**Official Transcript of Proceedings**  
**NUCLEAR REGULATORY COMMISSION**

Title:                   Advisory Committee on Reactor Safeguards  
                                  Plant License Renewal Subcommittee

Date:                    Wednesday, August 18, 2010

7 KEWAUNEE POWER STATION

# Switchyard Layout in 2006

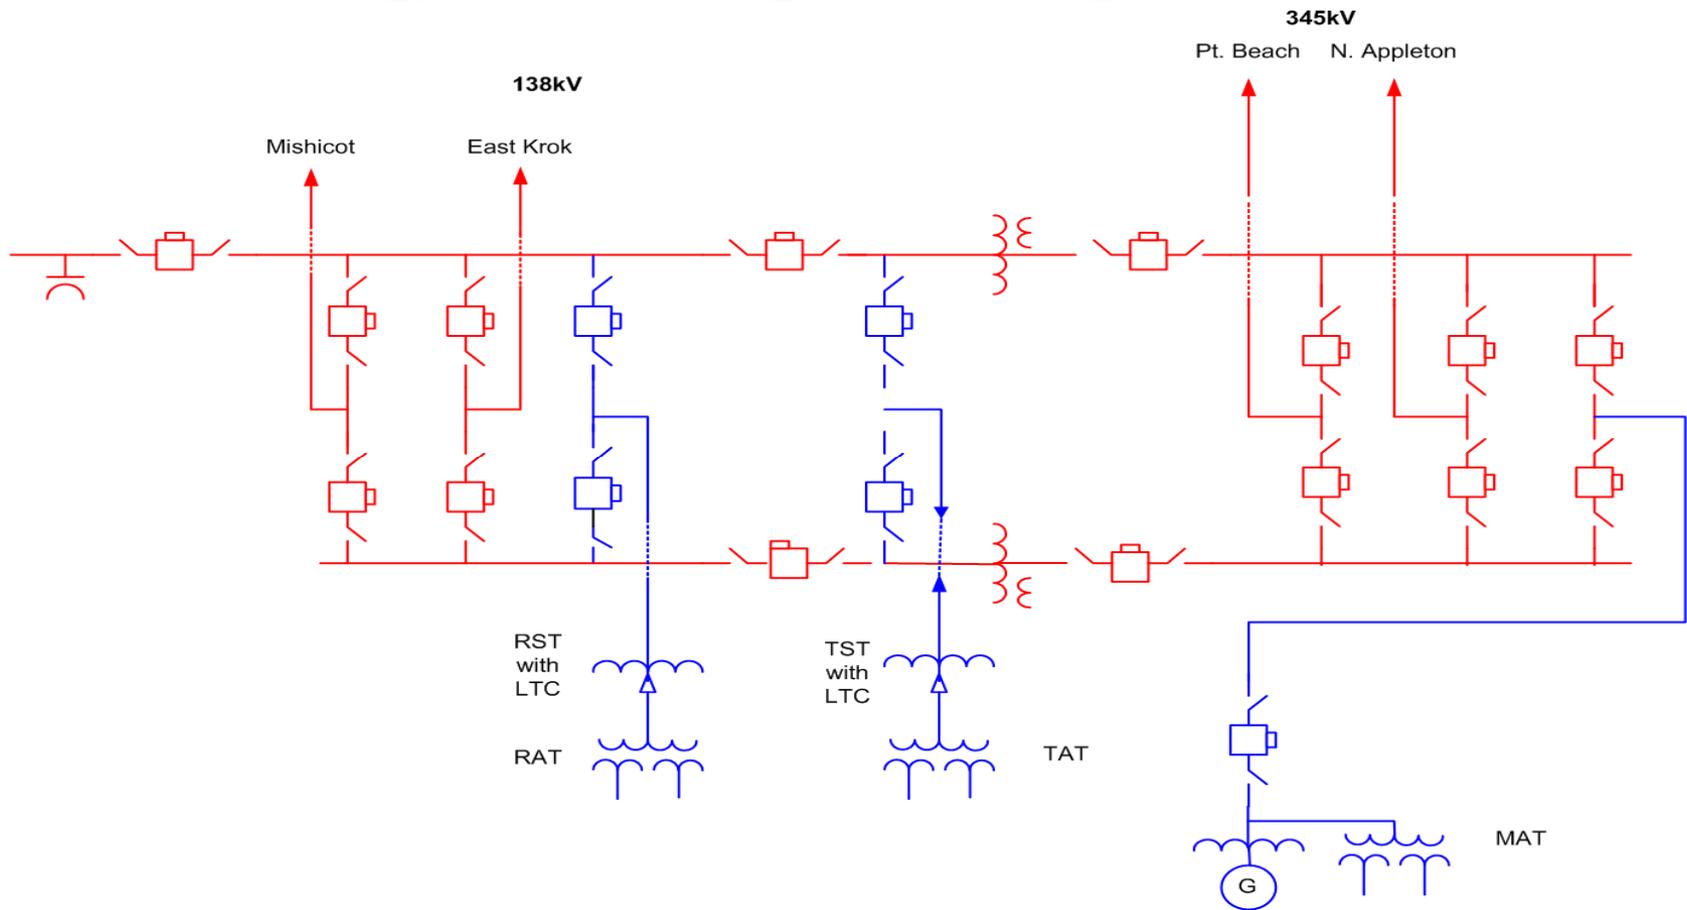
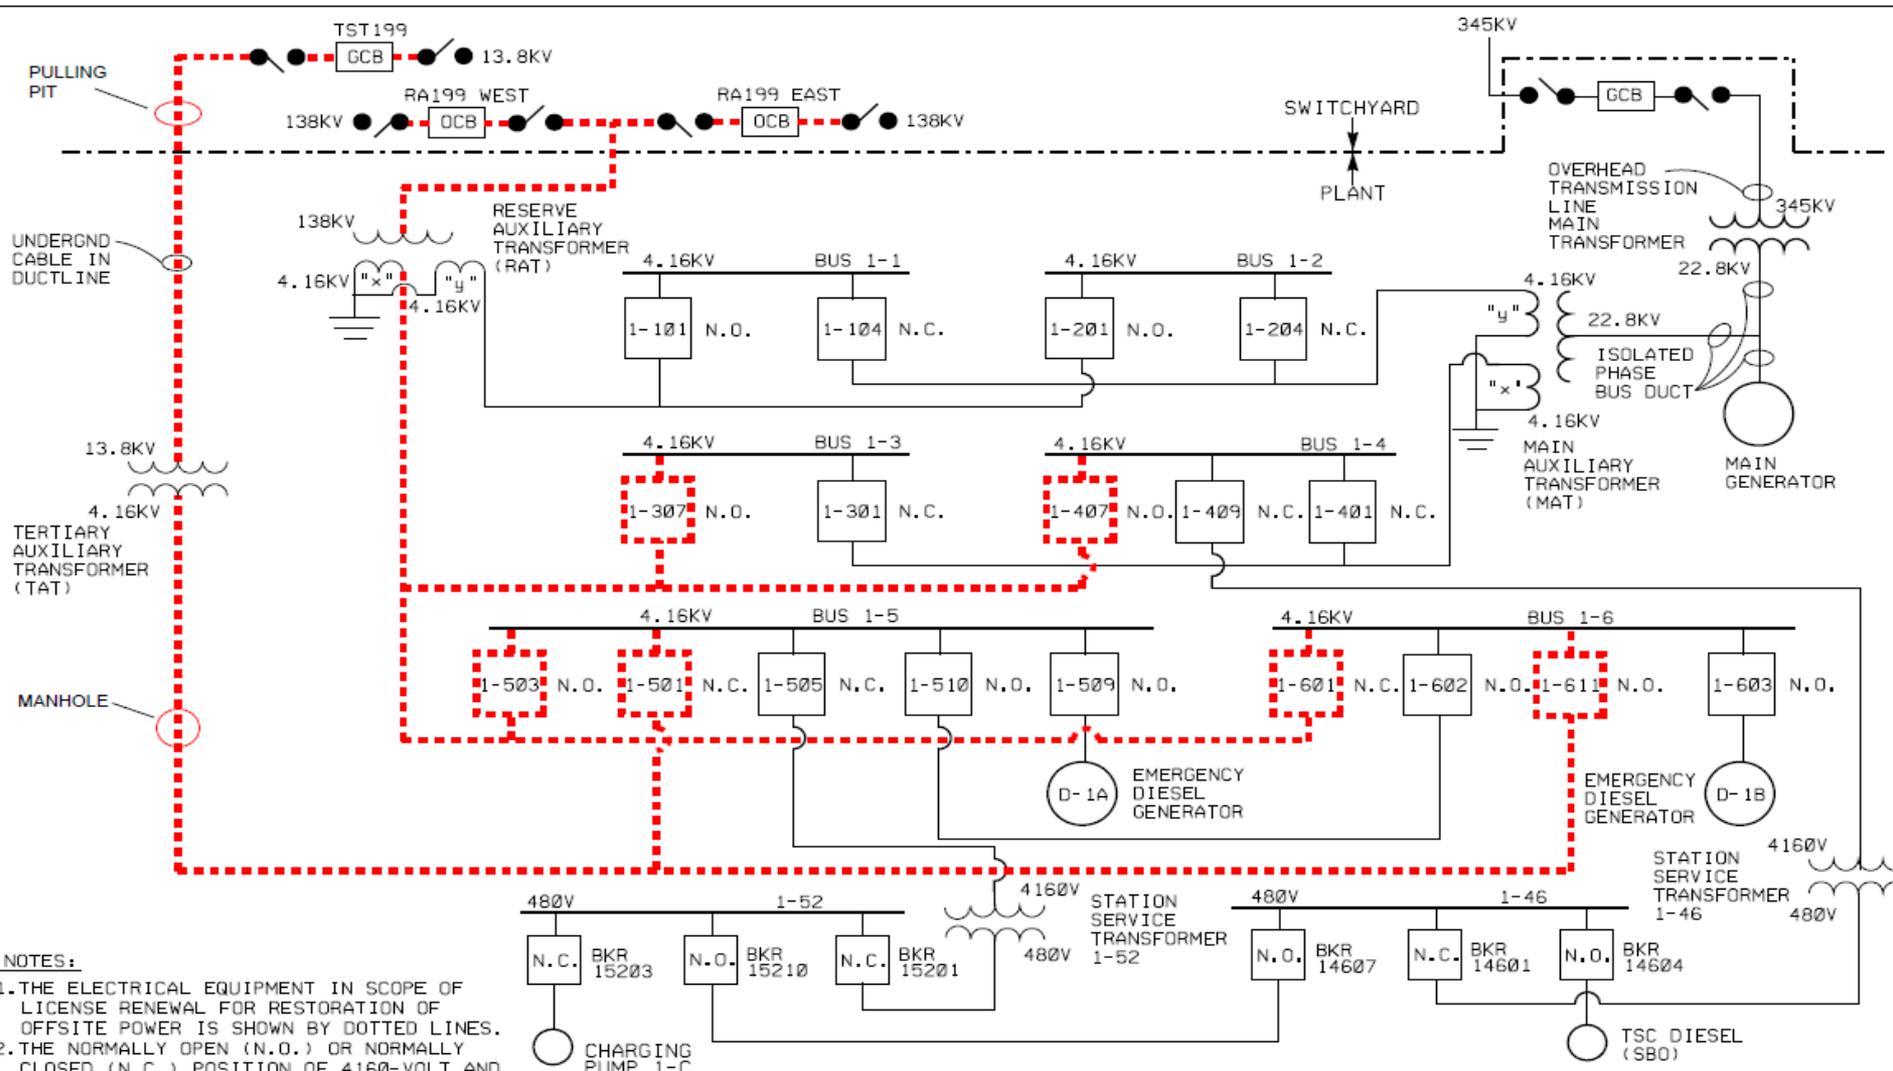
24 MEMBER STETKAR: Stuart, this drawing  
25 you're showing here was not in the license renewal

1 application; is that correct?

4 MEMBER STETKAR: Well, okay, then on this  
5 drawing there is some nice red lines and there are  
6 some nice blue lines. What specific equipment is in  
7 scope for license renewal on this drawing if this is  
8 indeed the configuration that will be in effect at the  
9 time of license renewal?

22 MEMBER STETKAR: Could you go back to the  
23 as-is drawing then?

1                   MEMBER STETKAR:     This is the drawing  
2 essentially that is in the license renewal  
3 application. I mean electrically.

12 Finally the last two bullets, if we could  
13 go to the next slide. Got two slides here. One shows  
14 our switchyard layout in 2006, and then the next one  
15 will show the switchyard once all the modifications  
16 that we are performing are complete. But this first  
17 slide shows, as you can see there are two 138 kV lines  
18 or kV buses on the left side of this drawing, and two  
19 345 kV lines to Point Beach and North Appleton.

20 One of these station offsite power  
21 sources, the tertiary aux transformer, it's denoted by  
22 the acronym TAT, in the middle of the drawing there,  
23 was fed directly from a tertiary winding on the 345  
24 and 138 kV transformer. The other offsite power  
25 supply, the reserve aux transformer which is denoted

5 So the modifications that we are doing, as  
6 you can see from this slide, include the following  
7 improvements. When all the modifications are complete  
8 we will have a double ring bus for both the 138 kV bus  
9 as well as the 345 kV bus. We are replacing or  
10 actually we have replaced the TAT with a new  
11 transformer and our RAT will be replaced in our  
12 upcoming refueling outage.

13 We have also replaced our main generator  
14 step-up transformers, and we have added a second 345  
15 to 138 kV transformer - or I'm sorry, we will be  
16 adding that this refueling outage.

17 We have also added new supply transformers  
18 as you will see on the bottom of that drawing, RST  
19 with LTC, to both the RAT and the TAT. That LTC is a  
20 low tap changer capability, and that will be  
21 functional following our 2011 refueling outage.

2 MR. YUEN: That is correct. This is just  
3 for presentation purposes.

10 MR. AITKEN: We do have another drawing we  
11 can go to.
